Kent Pedestrian Guard Railing Assessment

Sittingbourne – Consultation Report (Version 3)

Project Number B1649000

Illustrated Diagram of site 10

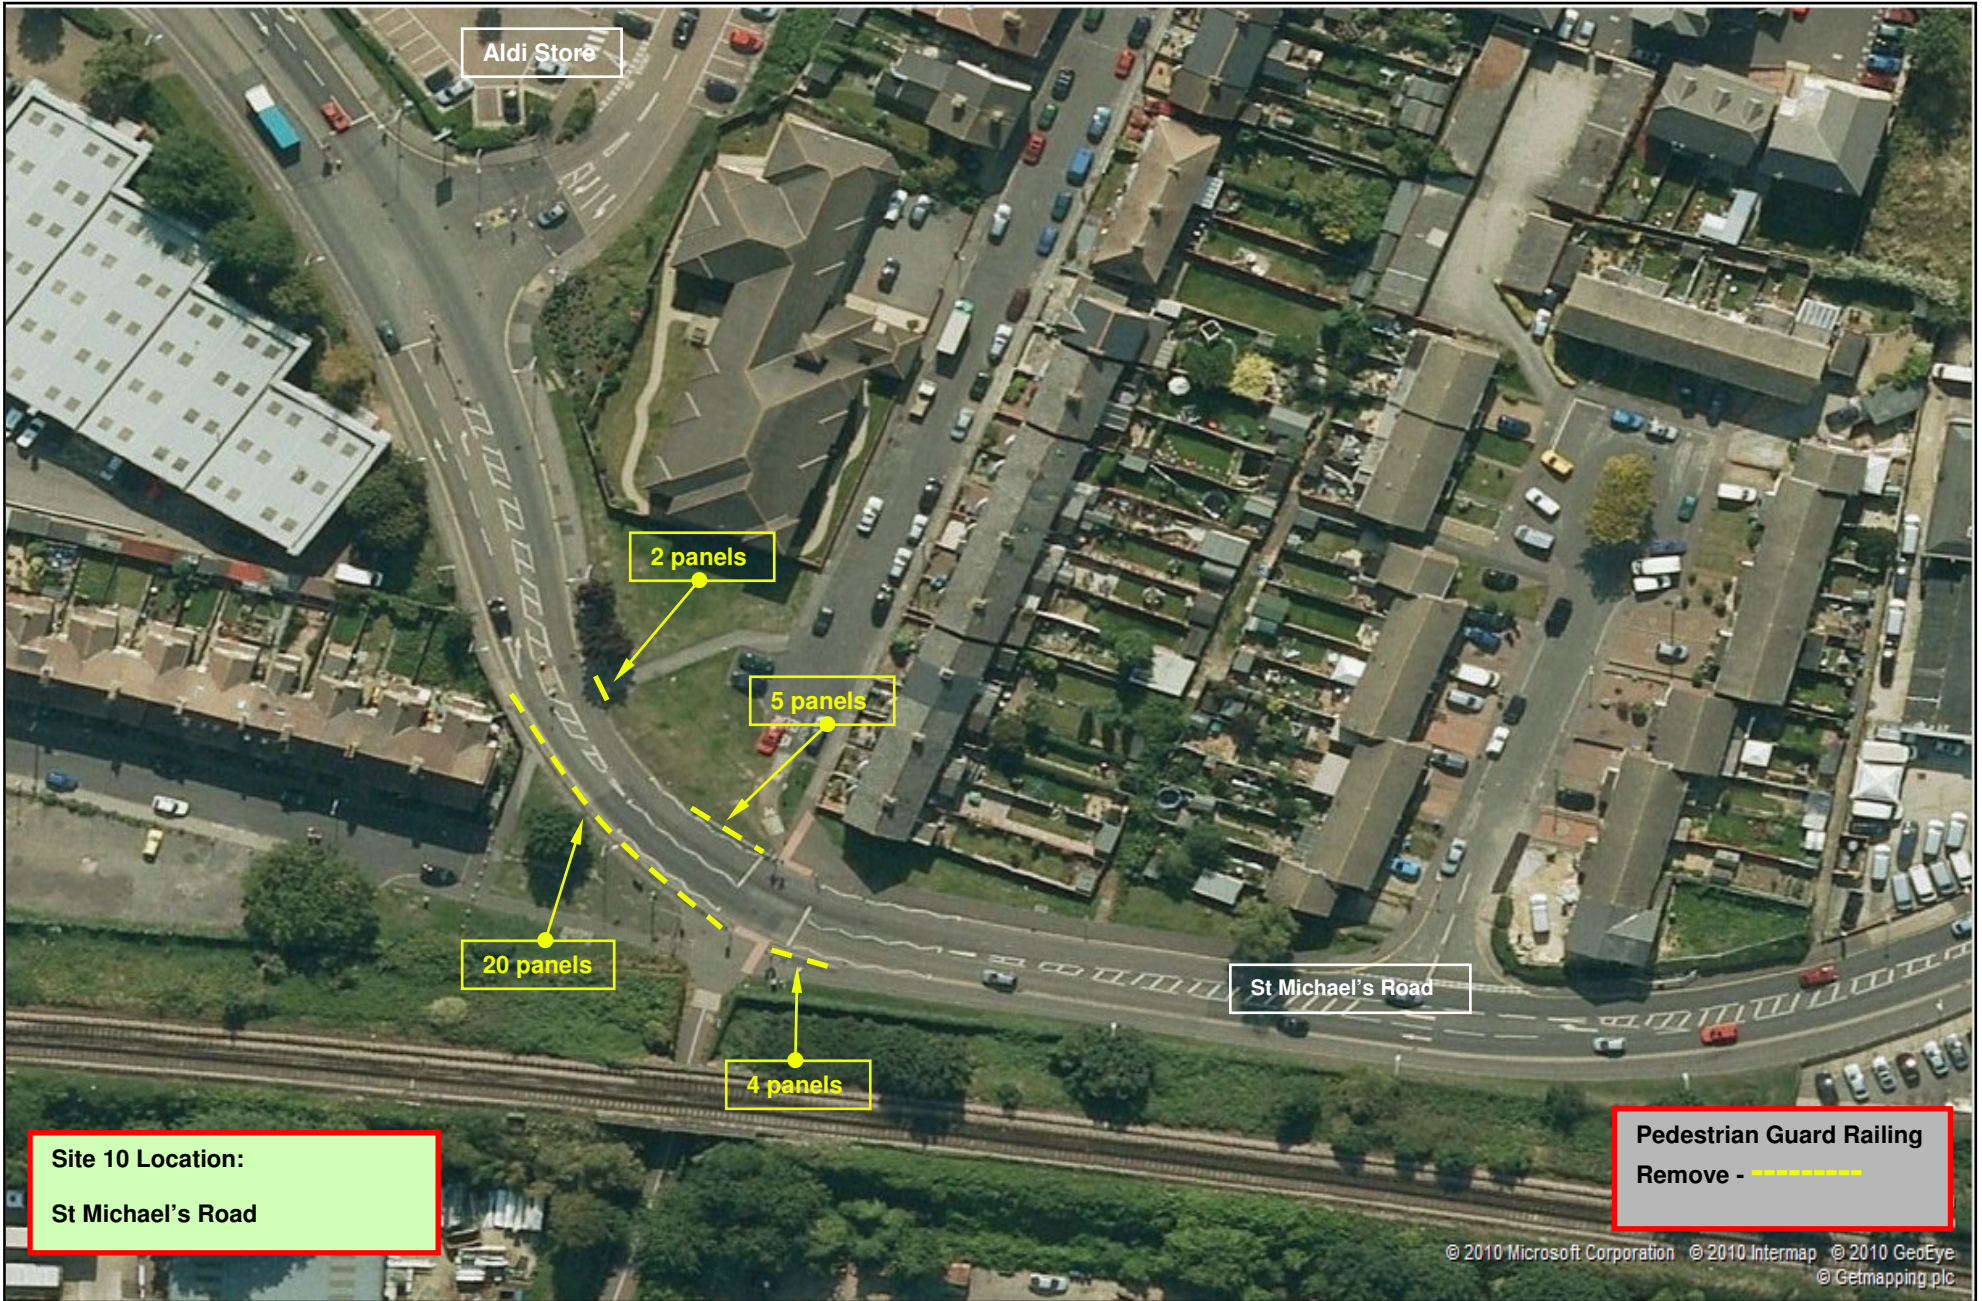
The pedestrian guard railing offers little benefit as a guide or protective device.

- **It is recommended to remove the pedestrian guard railings at site 10.**

Illustrated Diagram of site 11

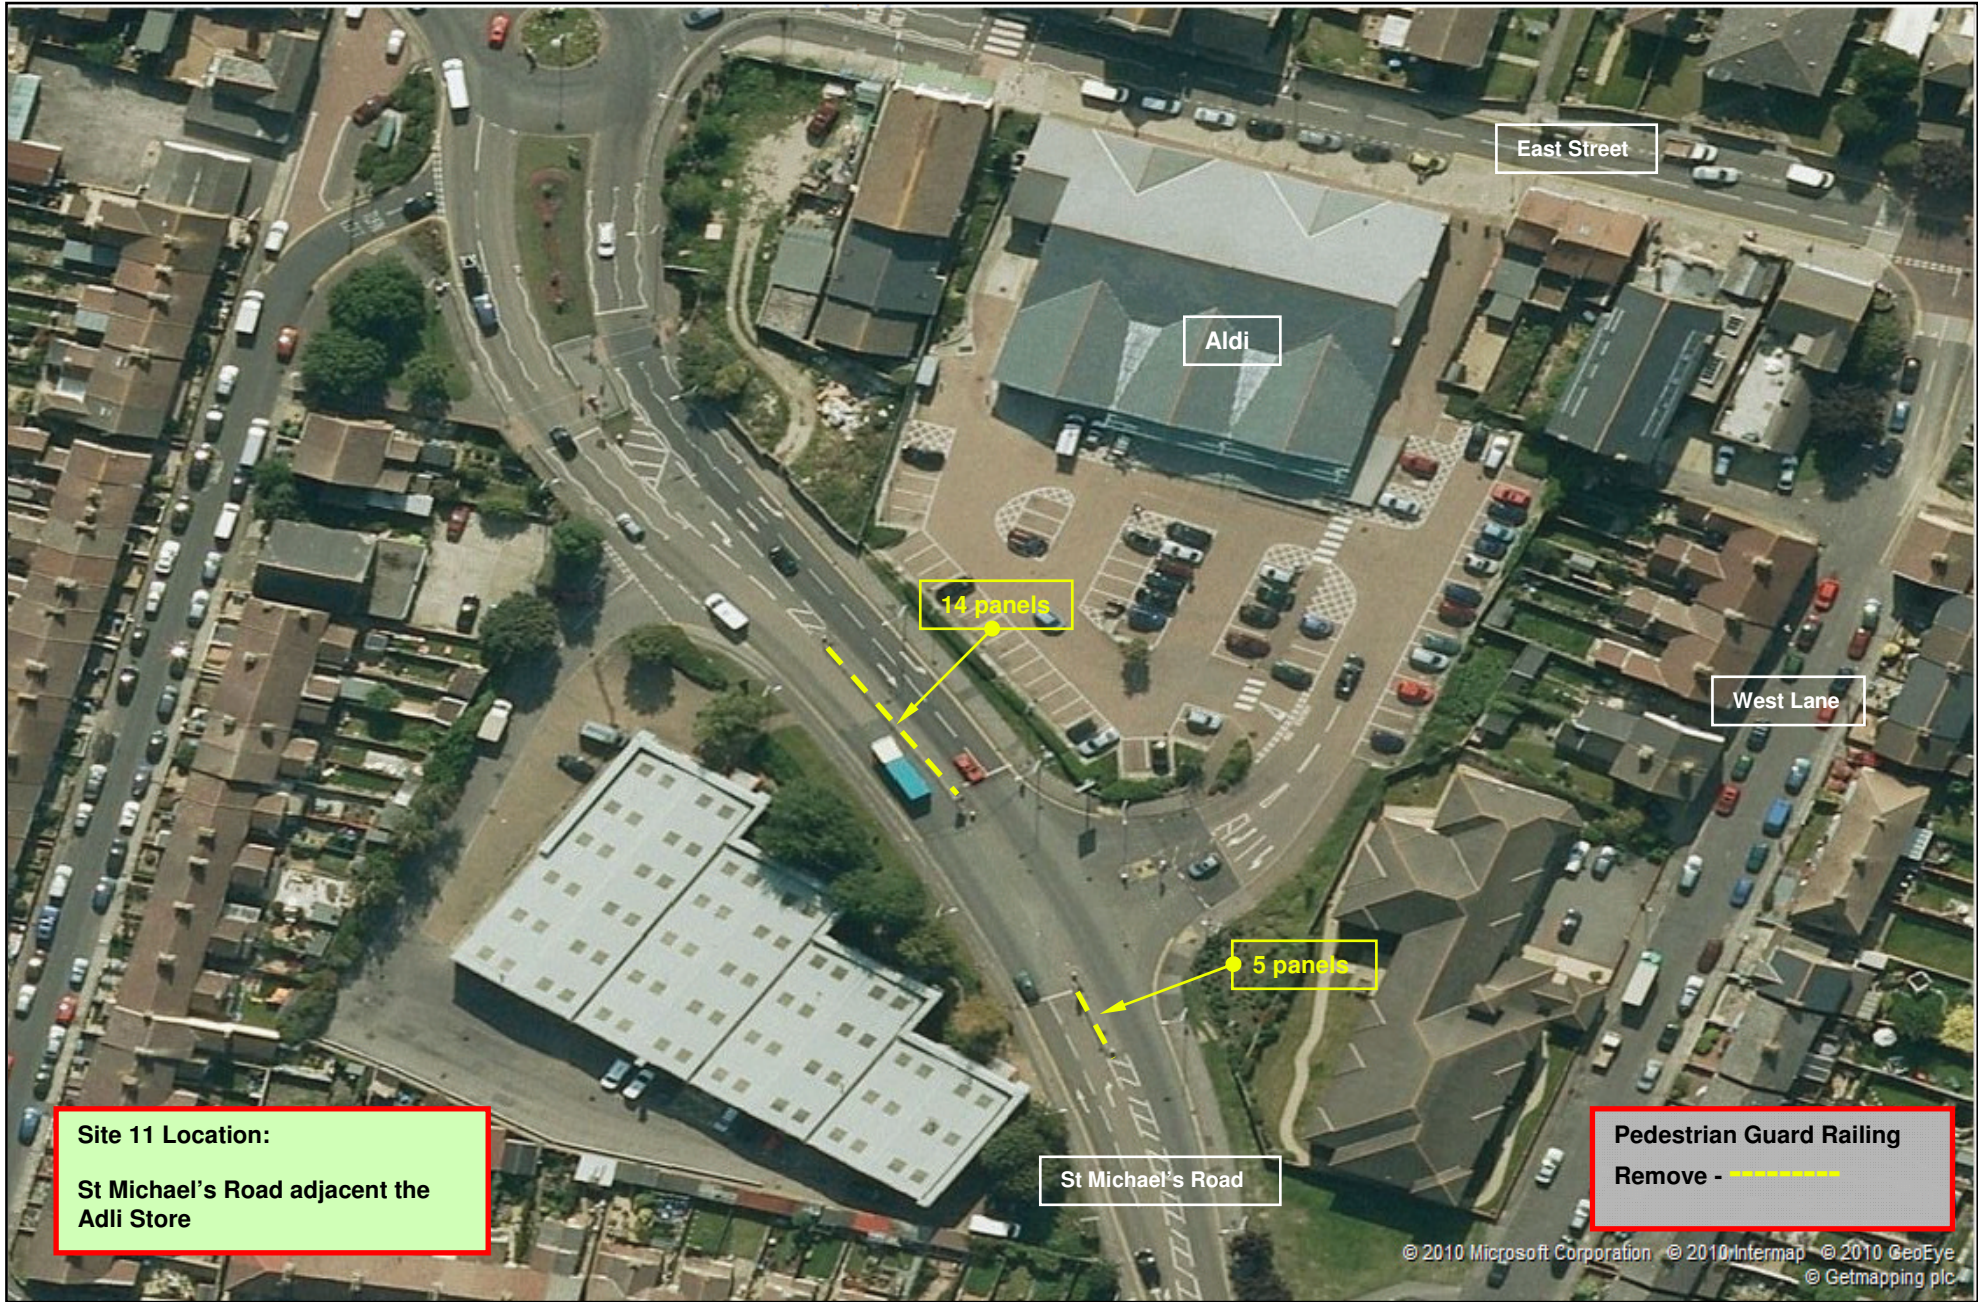
The central reservation guard railings offer little benefit as a guide or protective device.

- **It is recommended to remove the central reservation guard railings at site 11.**
